Response to reviewer #1 Recent six-year atmospheric CO₂ concentration at the summit of Mt. Fuji observed by a battery-powered CO₂ measurement system

Shohei Nomura^a, Hitoshi Mukai^a, Yukio Terao^a, Toshinobu Machida^a and Yukihiro Nojiri^{a,b}

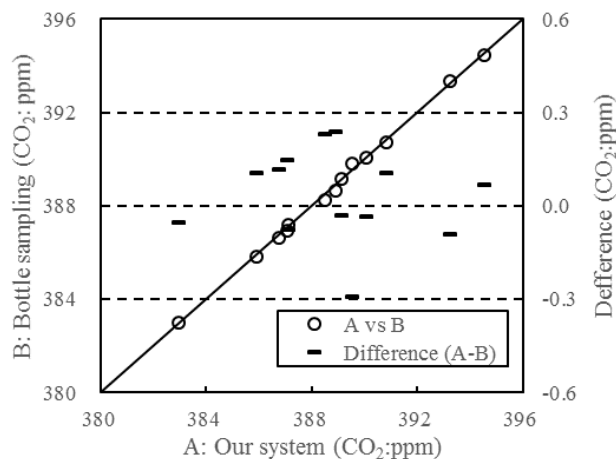
9. Concerning the experimental set-up, I strongly recommend to change the PTEFE with stainless steel or Synflex 1300 tubing (PTFE is well known to be not optimal for CO2 sampling). By which frequency did you change the PTFE tubing? I would like to see more information about the working standards for routinely calibration of the system (i.e. flask material, mixture matrix, pressure regulators) and more discussion about the choice of your calibration strategy (are 4 min sufficient enough to obtain stable measurements?).

We added one figure (Fig. 3) to show the typical NDIR signal for standard gas and outside air measurement. As shown in the figure, signal became stable 2 min after starting measurement. So, we discard the data for first 2 min and averaged data for the rest of the time (in the case of standard data was averaged for 2 min, in the case of the air data was averaged for 6 min.) The measurement sequence (3 standards=> room air => outside air) was repeated for 4 times and 2nd, 3rd, 4th data were averaged as represented data (1st cycle data was discard, because we would like to most stable data). Tish detail was written in 3.1 Analytical performance.

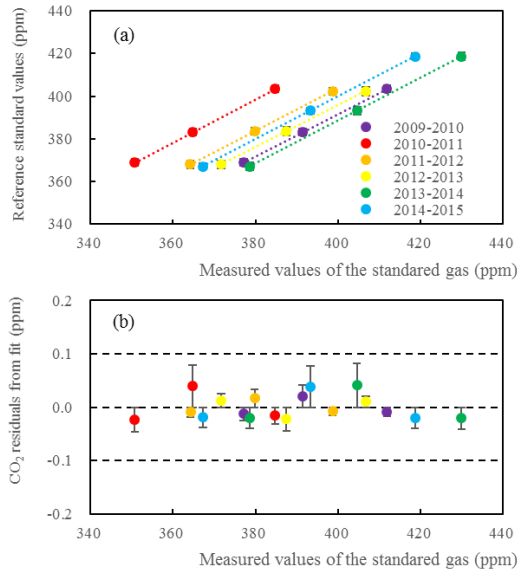
11. I think that the authors should spent more work in presenting an assessment of the quality of the system performance. Along the manuscript, the authors provided a statistical analysis (Fig. 5 of the manuscript) of the standard deviation of the measured value of standard gases. This information can be useful to assess the “long-term repeatability” of the measurements (see e.g., Lebegue et al., AMT, 2016). However, to better exploit this point, I would like to see this analysis also split as a function of the different standard gases used and/or as a function of the different years. It should be interesting to see the absolute difference between the CO₂ measured values of the standard gases and the reference standard values. Moreover I would like to see information about the uncertainty or expanded uncertainty of the measurements achievable by this system, which is an important parameter missed in the paper.

>We added Table 1 which showed the CO₂ first calibrated values of the working standard gas and the lastly calibrated values after use. The differences between them were about 0.1 ppm, means that they are very stable in the cylinders. Also, we can correct this kind of small deviation in the standard gas values by using weighted average with time (even so maybe small uncertainty (30% of 0.1 ppm = 0.03ppm = detection limit of NDIR in NIES lab) will be left). If we looked at the linearity of the calibration curve measured by the system, the deviation from the calibration curve was also small (at most 0.05ppm). Real signal (10 s average) had 0.05ppm on average as a standard deviation for repeating measurement. It is also said that NIES CO₂ standard series (NIES09 standard) matched with NOAA (WMO) standard within 0.09ppm.

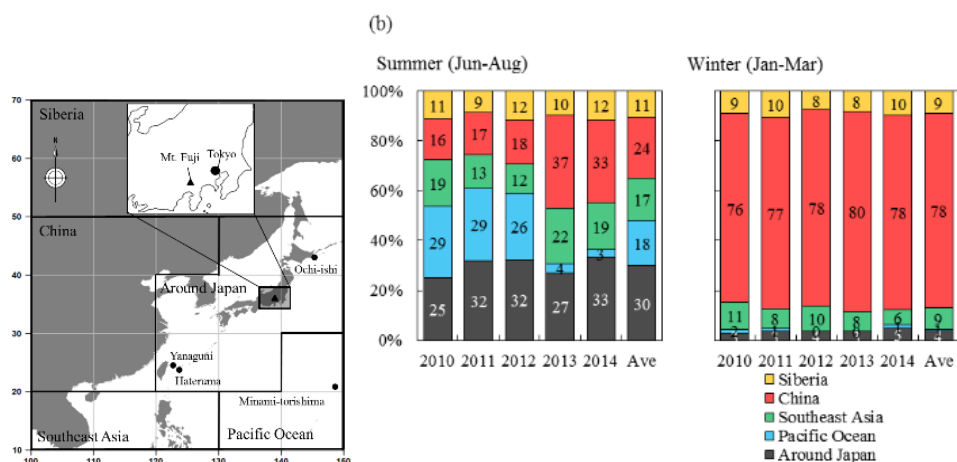
17. Pag 8, line 11: “it was evident that. . .often see in July”. It is difficult from this plot to obtain information about monthly values. I would suggest to replace this plot with monthly mean values and related error bars (representing the associated 95% confidence interval). This would also allow to skip Table 1.

>If the CO₂ data of Mt. Fuji change from daily data to monthly data, extremely low concentration and high concentration of the CO₂ data of Mt Fuji cannot be seen. These specific events are characteristic in the CO₂ concentration of Mt. Fuji. We remained the figure of daily CO₂ data of Mt. Fuji. Table 1 as monthly average was transferred to supplementary material to skip it.
